08-22 SWEETGREEN #MN178 EDINA, MN (TAB, IAQ)

Project Issue Information

Issue Name : RTU-2 PKG (air purifier installation)

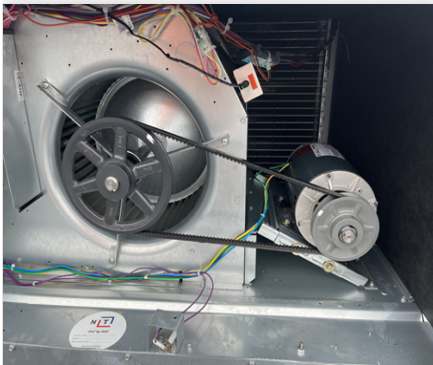
Description : Exposed wiring not covered. Recommend exposed wiring is covered with split loom to prevent long term damage to wiring.
